Access Compliance Report

Public Rights-of-Way

Intersection ID: 11783	Main Street: N_GRAHAM_ST	Cross Street: W_5TH_ST	Location:	W
ADA ID: C3204015F67D	Ramp Type: PerpDiag	Initial Pass/Fail: Fail	Overall Compliance: No	Severity Score: 25

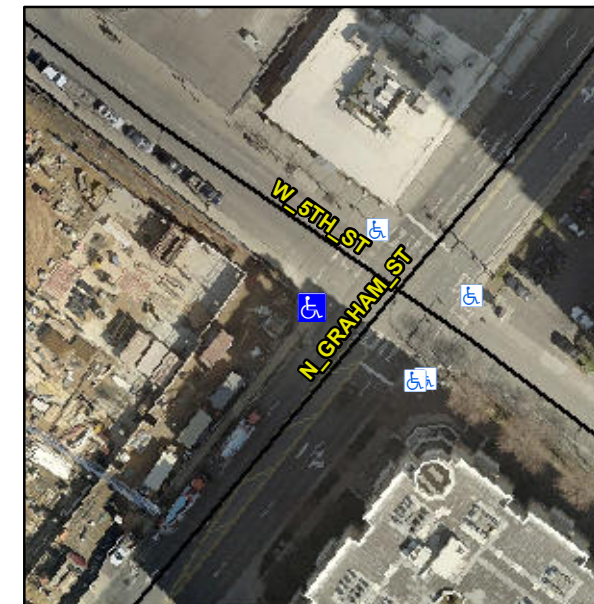
R304.2.2, R304.5.3

Compliance	Description	Data	Compliance	Description	Data
N/A	Ramp Length (in)	61.0	No	Ramp Slope (%)	9.2
Yes	Ramp Width (in)	58.0	No	Ramp XSlope (%)	6.0
N/A	Flare Type LT	N/A	N/A	Flare Type RT	N/A
N/A	Flare Slope LT (%)	N/A	N/A	Flare Slope RT (%)	N/A
N/A	Flare Traversable LT?	N/A	N/A	Flare Traversable RT?	N/A
N/A	Landing Length (in)	N/A	N/A	DWS Provided?	N/A
N/A	Landing Width (in)	N/A	N/A	DWS Contrast?	N/A
N/A	Landing Slope (%)	N/A	N/A	DWS Length (in)	N/A
N/A	Landing X Slope (%)	N/A	N/A	DWS Full Width?	N/A
N/A	Landing Curb? (Y/N)	N/A	N/A	DWS Offset (in)	N/A
N/A	Shared Landing?	N/A			
N/A	Gutter Ponding?	N/A	N/A	Gutter Slope (%)	N/A
N/A	Gutter Lip Ht (in)	N/A	N/A	Gutter X Slope (%)	N/A
N/A	Painted X Walk1?	Yes	N/A	Painted X Walk2?	Yes
	X Walk 1 Direction	To SE		X Walk 2 Direction	To NE
N/A	X Walk 1 Width (in)	100.0	N/A	X Walk 2 Width (in)	98.0
	X Walk 1 Slope (%)	3.0		X Walk 2 Slope (%)	2.2
	X Walk 1 X Slope (%)	1.1		X Walk 2 X Slope (%)	4.2

Remove & Replace Curb Ramp With Two New Directional Ramps or Equivalent.
